Site Plan and Design Review Staff Report and Recommendation

REPORT DATE:	December 12, 2022
HEARING DATE:	December 19, 2022
PROJECT NAME:	West Grove Apartments
FILE NUMBER:	311-22-000028-PLNG
LAND USE REQUEST:	Site development and design review of a proposed 45-unit multi-family apartment complex.
PROPERTY LOCATION:	2320 & 2230 26 th Avenue Washington County Tax Lots 1N331CA01500 & 1N331CA01700
APPLICANT:	Evan Scesa – Creekwood Homes Inc.
OWNER:	John LePari, Hunter LePari, Aimee LePari & Joseph LePari
COMPREHENSIVE PLAN MAP DESIGNATION:	High Density Residential
ZONING MAP DESIGNATION:	Residential, High (RH)
APPLICABLE STANDARDS AND CRITERIA:	City of Forest Grove Development Code §17.2.300 et. seq. <i>Design Review</i> §17.2.400 et. seq. <i>Site Development Review</i> §17.2.100 et. seq. <i>Adjustments</i> §17.3.100 et. seq. <i>Residential Zones</i> §17.5.100 et. seq. <i>Tree Protection</i> §17.7.200 et. seq. <i>Solid Waste and Recycling</i> §17.8.000 et. seq. <i>General Development Standards</i>

REVIEWING STAFF:	Amy Kreimeier (AICP) Senior Planner
RECOMMENDATION:	Staff recommends approval with conditions

PRELIMINARY ALTERNATE SITE PLAN WEST GROVE APARTMENTS CREEKWOOD HOMES FOREST GROVE, OR

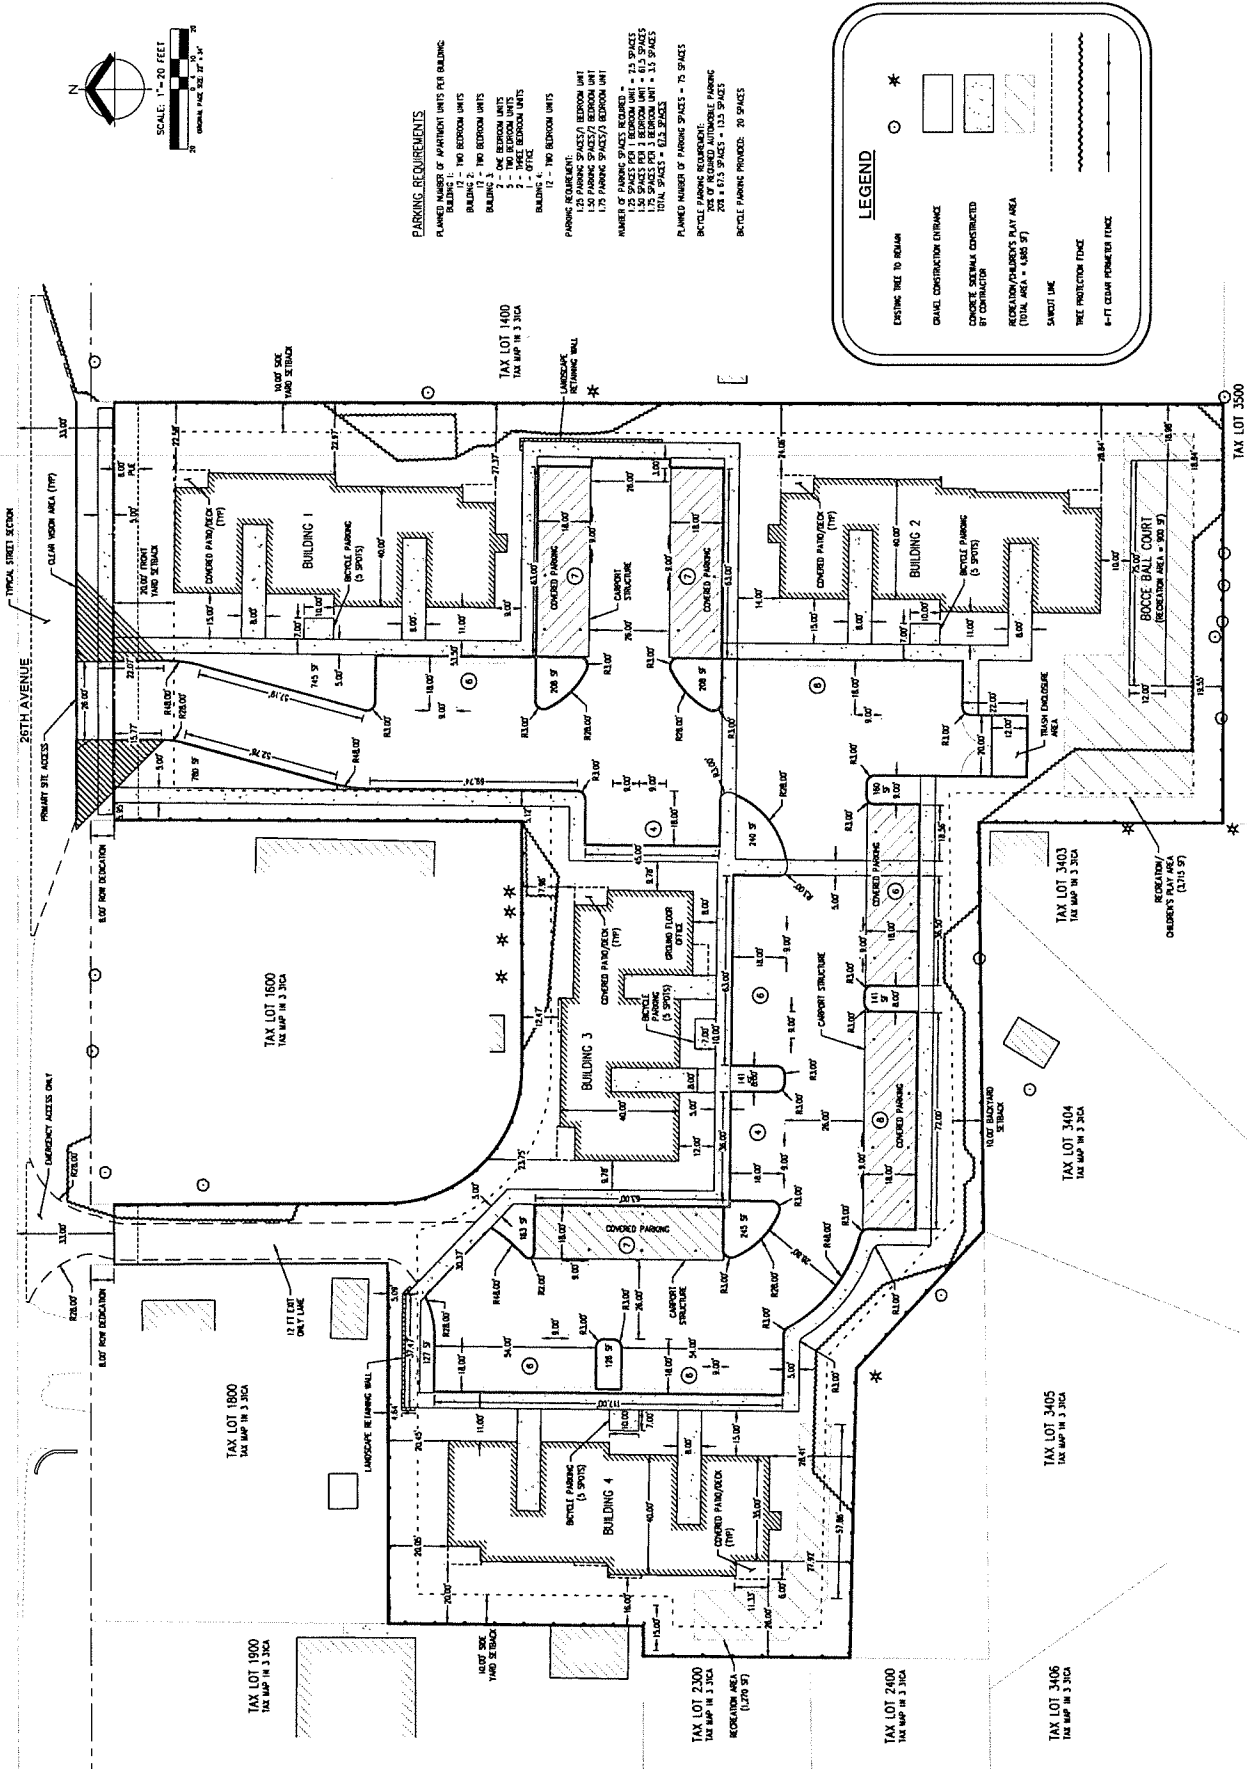
5. The Preliminary Alternate Site Plan proposed and included in the plans as sheet P03, submitted on October 14, 2022, is not approved.
6. All plans shall be coordinated for consistency by the applicant. Any change or modification to one particular plan shall require the corresponding revisions on other plans. All plans shall be consistent with that approved by the Community Development Department. The applicant shall be responsible for correcting any inconsistency which may occur through error or omission during plan preparation or construction.

Adjustment

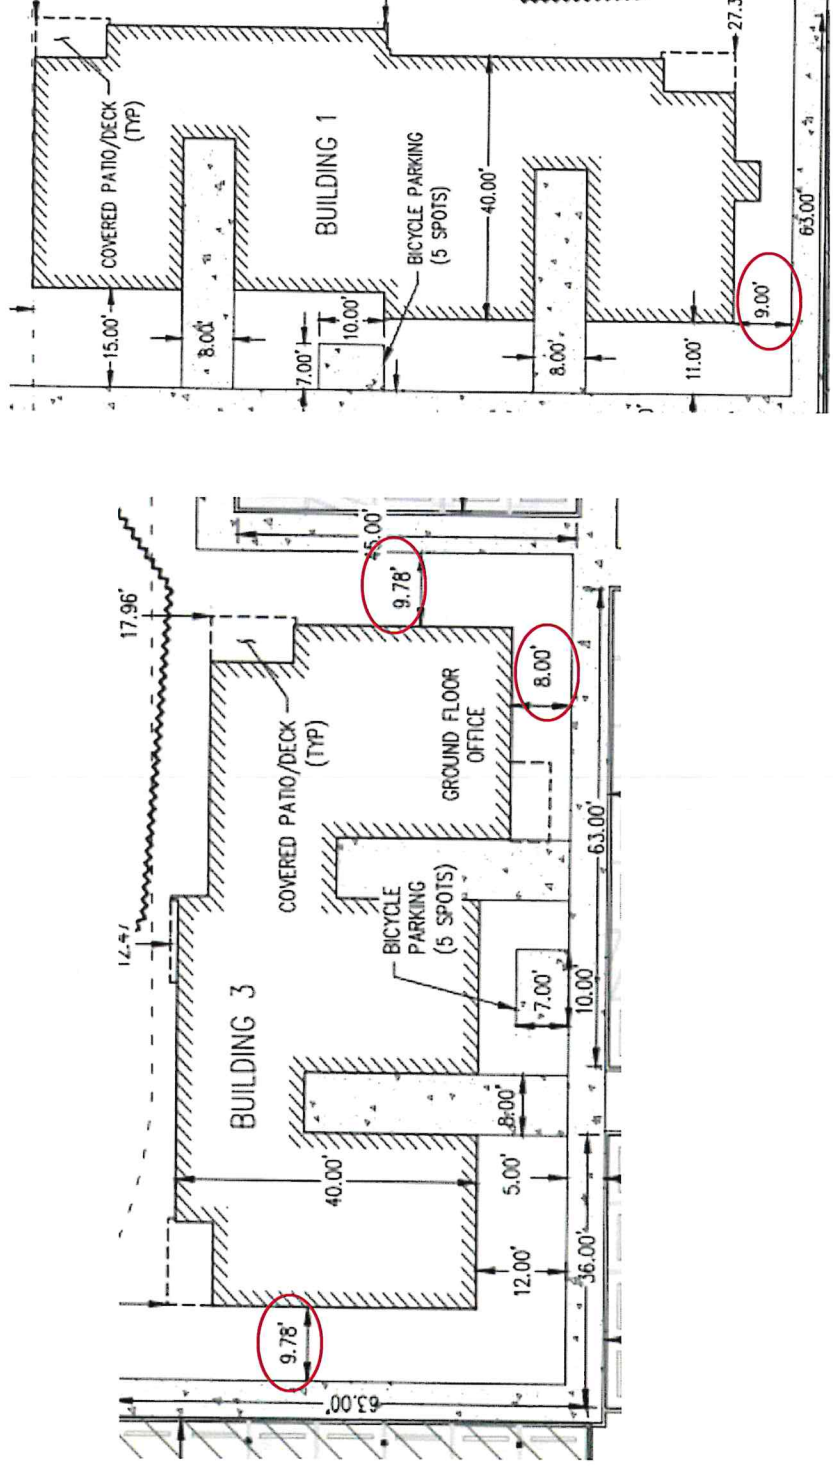
The specific site access and circulation standards for multi-family development of DC §17.8.140.A require pathways to be separated a minimum of 10 feet from dwellings. Buildings 2 and 4 meet this requirement, buildings 1 and 3 do not. As proposed, the east and west facades of Building 3 are 9.78 feet from the planned pedestrian path. The eastern portion of Building 3's southern facade is 8 feet from the pedestrian path. The southern façade of Building 1 is located 9 feet from the pedestrian pathway. A 10 to 20 percent reduction in this standard is one-to-two feet, and the applicant is requesting a two-foot encroachment into the 10-foot setback meaning this request qualifies for a Type II Adjustment Review.
